ENVIRONMENTAL COMMISSION MOTION 20220706-003

Subject: Mercedes Benz South Austin (SP-2021-0127C)

ITEM FOR ENVIRONMENTAL COMMISSION AGENDA

Project Name: Mercedes Benz South Austin
 Ordinance Standard: Watershed Protection Ordinance
 Variance Request: **To allow a private driveway access point through a Critical Water Quality Zone buffer**

SITE PLAN

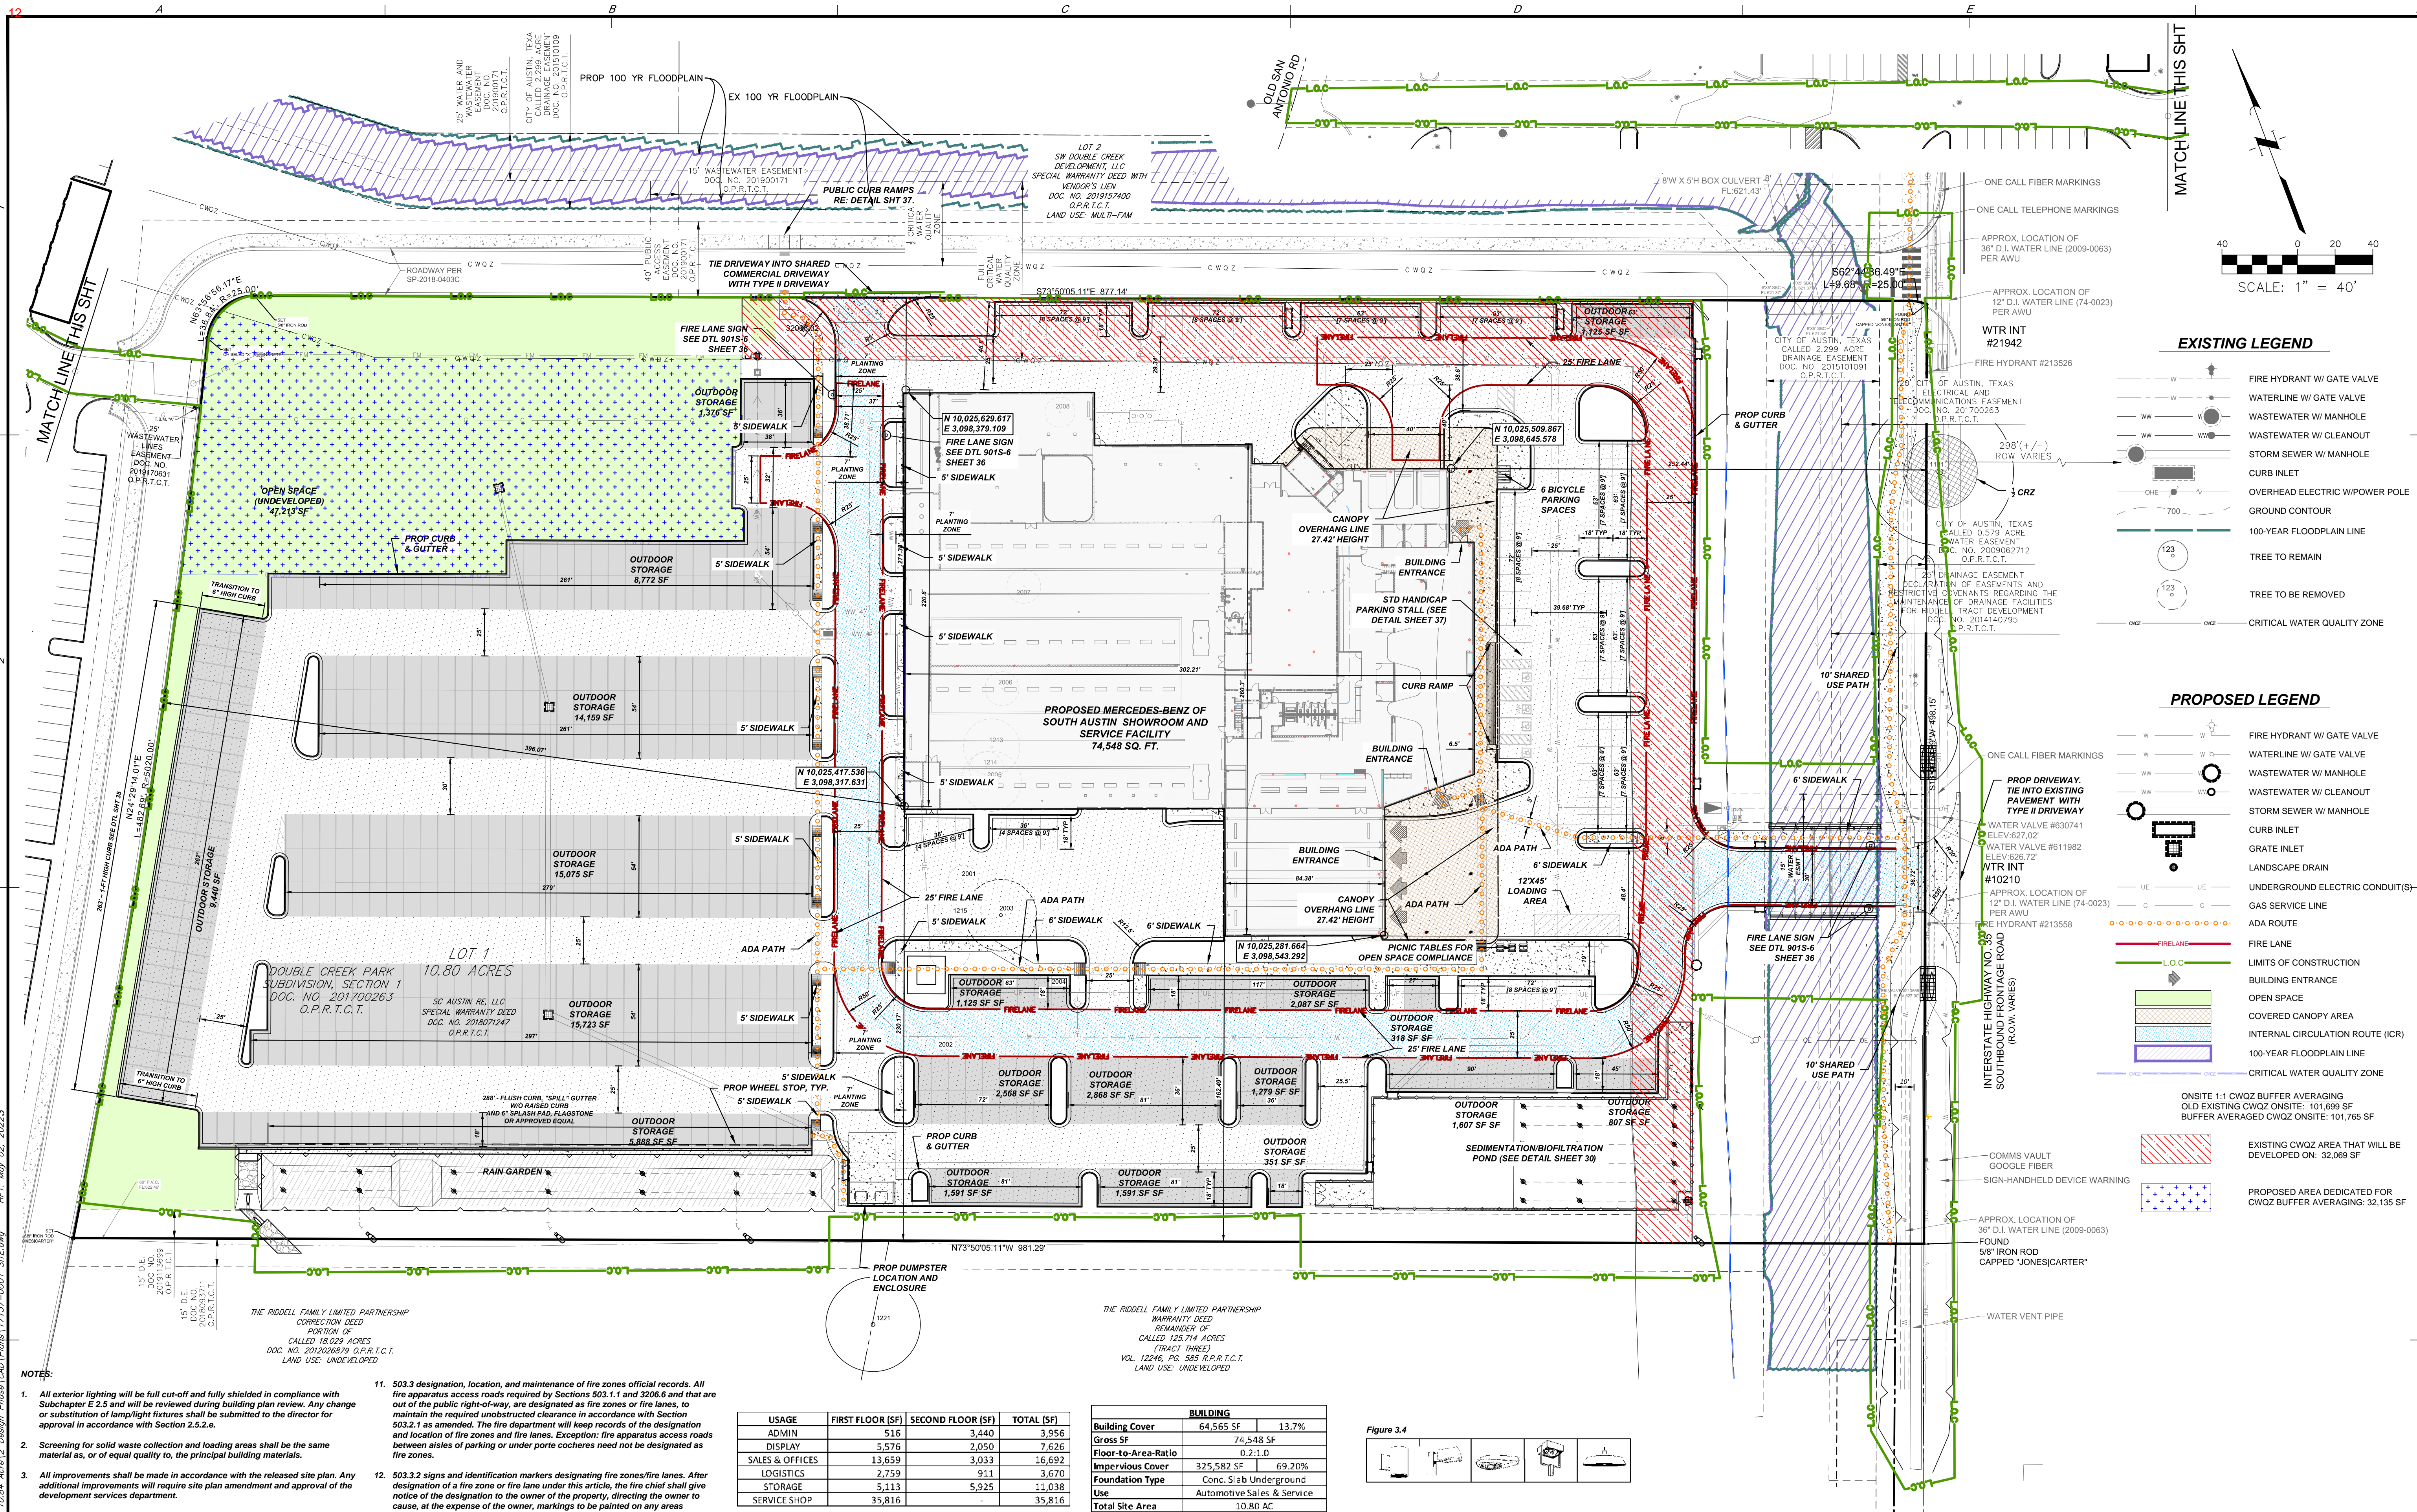
ON-SITE 1:1 CWOZ BUFFER AVERAGING

OLD EXISTING CWOZ ON-SITE: 101,699 SF
BUFFER AVERAGED CWOZ ON-SITE: 101,765 SF

PROPOSED AREA DEDICATED FOR CWOZ BUFFER AVERAGING: 32,135 SF
